# ADDENDUM No. 1

#### To JASPER MASTER LIFT STATION

October 16, 2025

# JASPER, GEORGIA

SEWER FORCE MAIN STA. 0+00 TO STA. 9+00

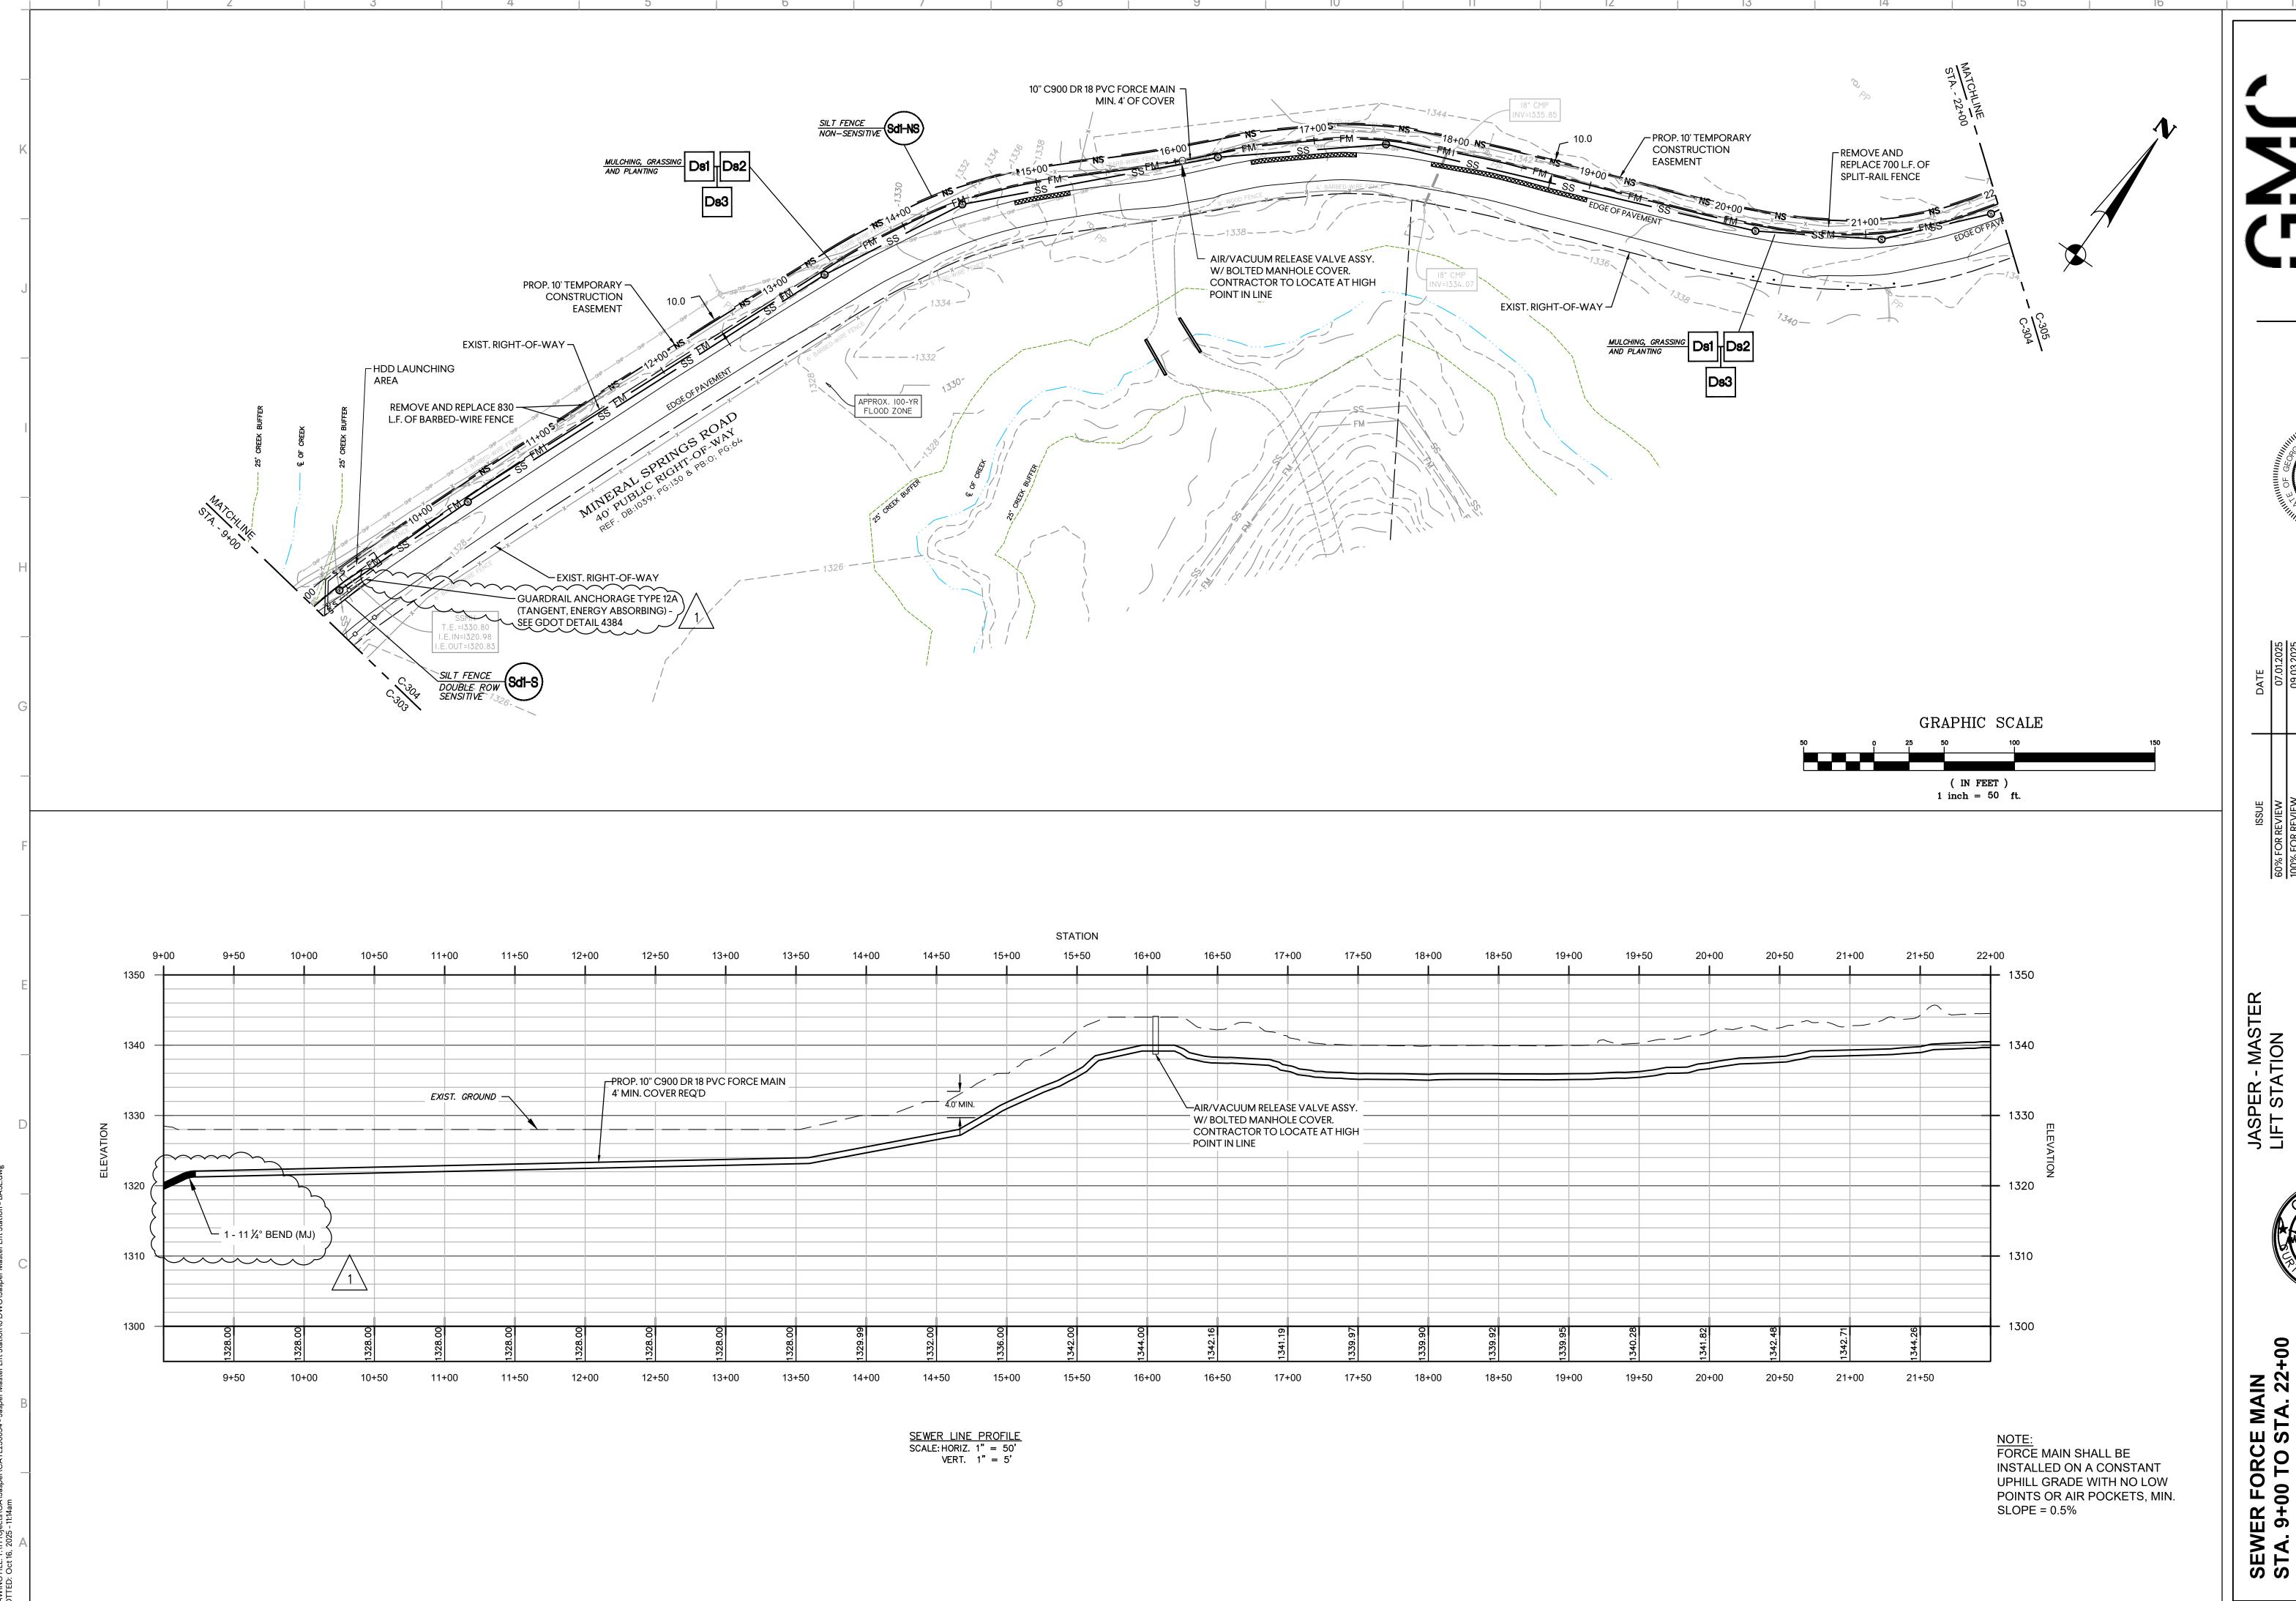
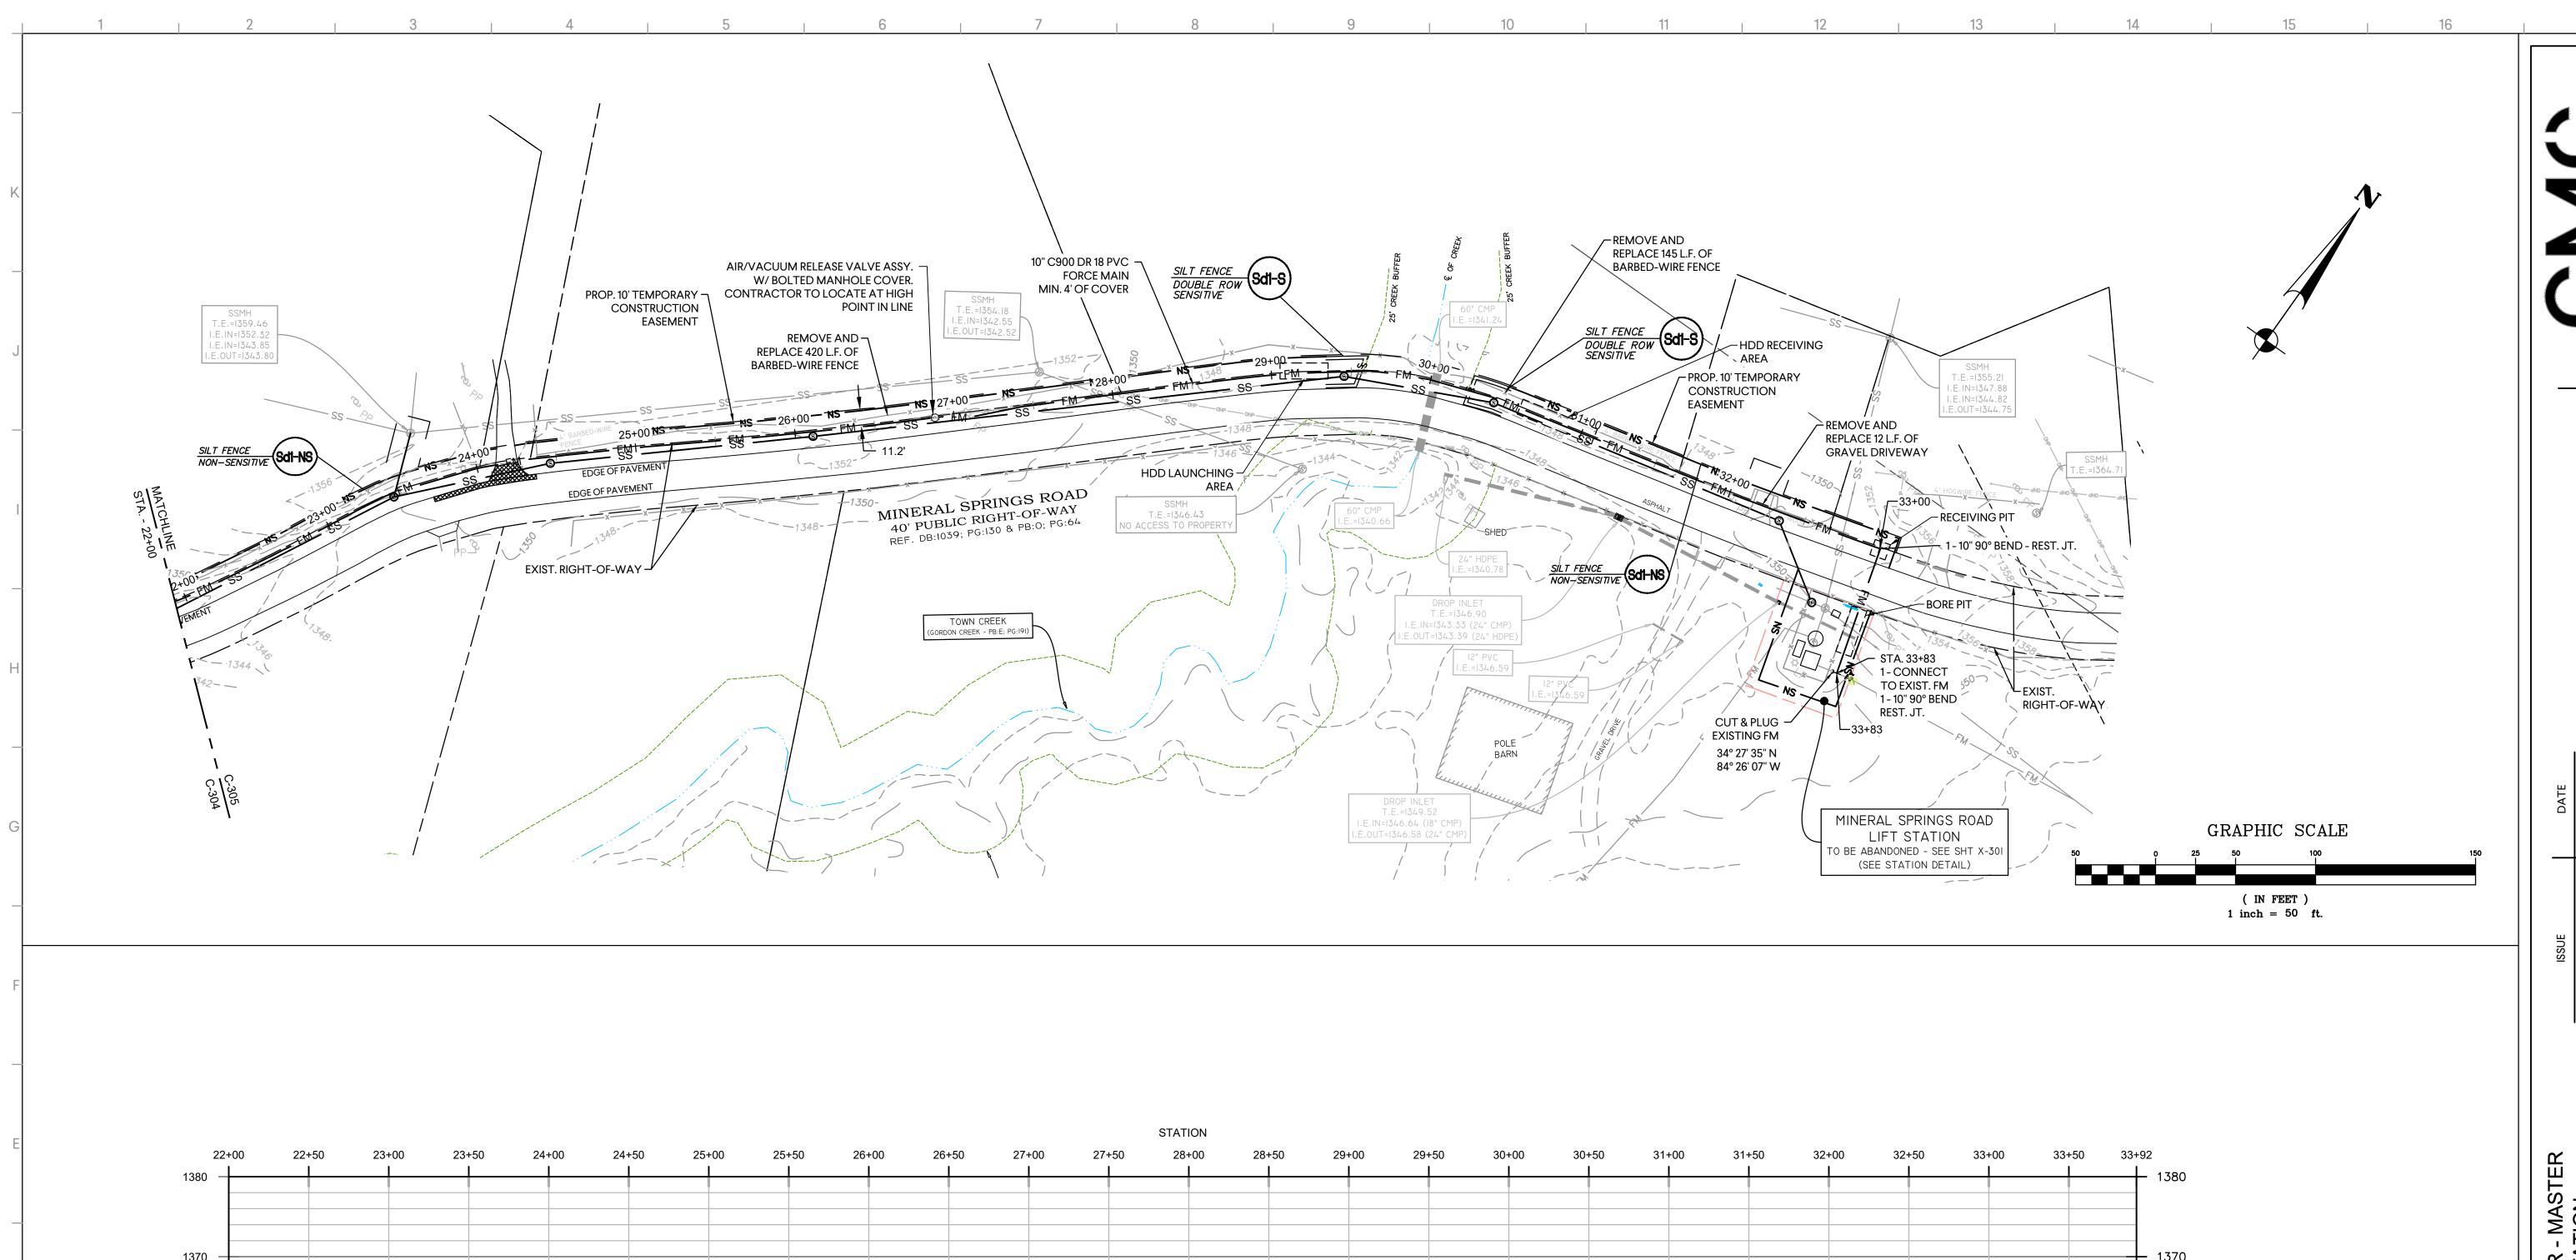
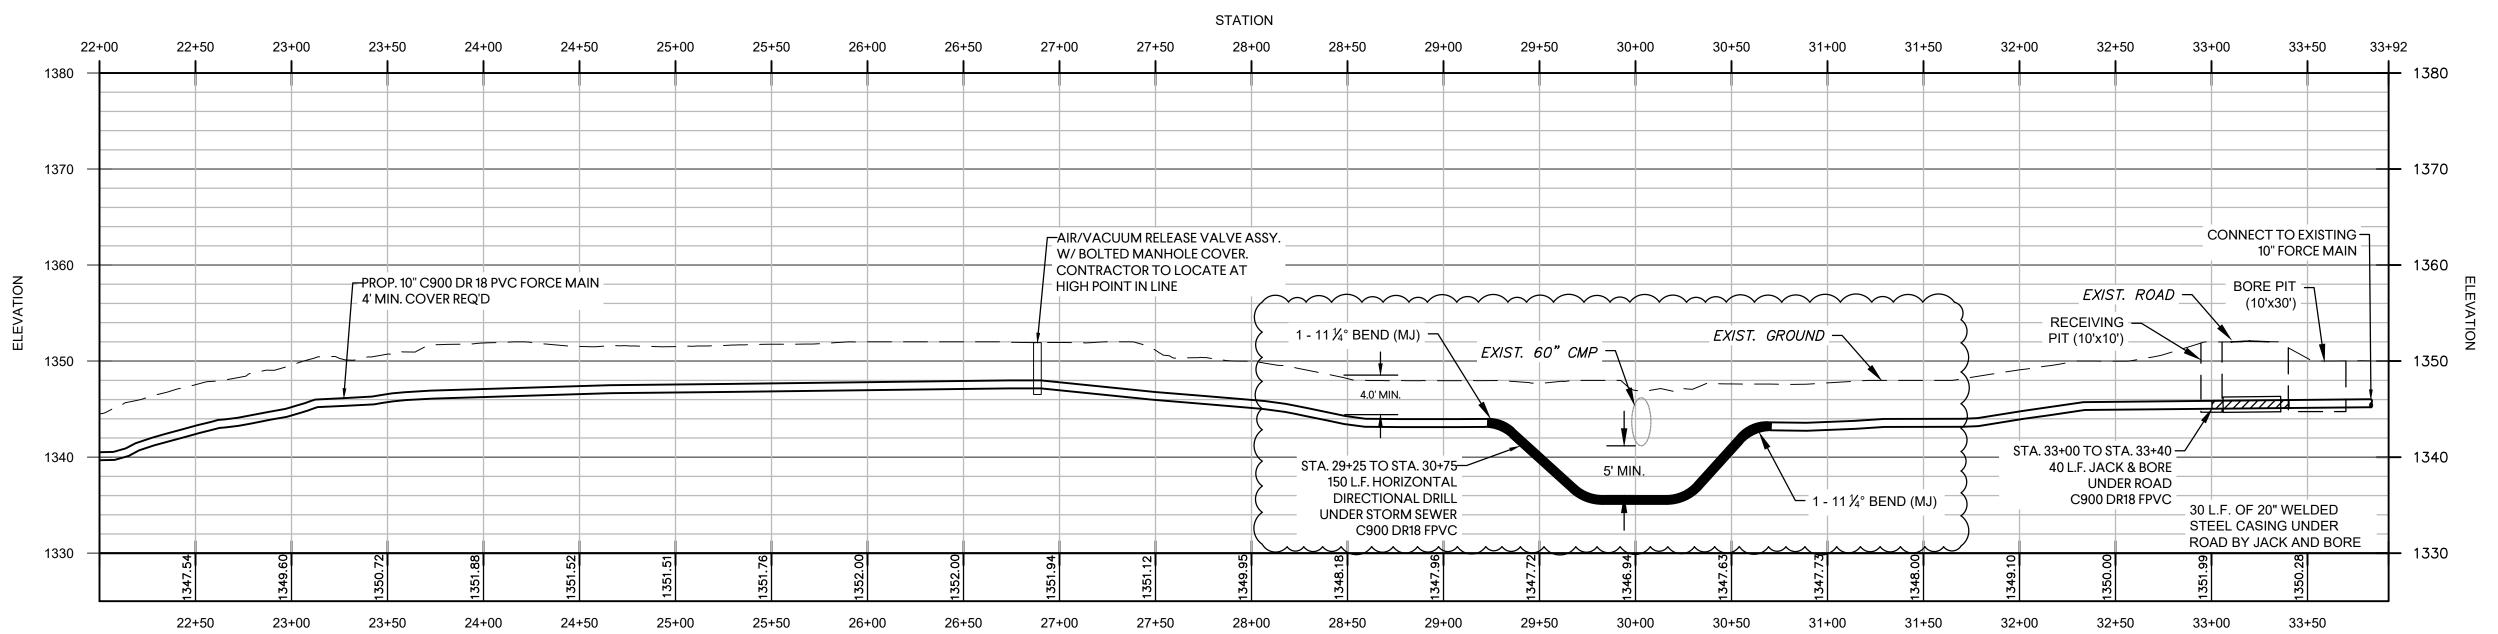
Engineer Response: On sheet C-306 (J&B#5), there is 135 LF of restrained joint pipe, but the Jack & Bore with casing is 125LF. The total amount of Jack & Bore should be 240 LF.

- 1. SECTION 43 25 13 SUBMERSIBLE CENTRIFUGAL PUMPS: Delete this section and replace with new SECTION 43 25 13 SUBMERSIBLE CENTRIFUGAL PUMPS attached. Changed the approved pump manufacturers.
- 2. Remove and replace sheets C-306, C-307, C-308 and C-901 with the revised sheets.
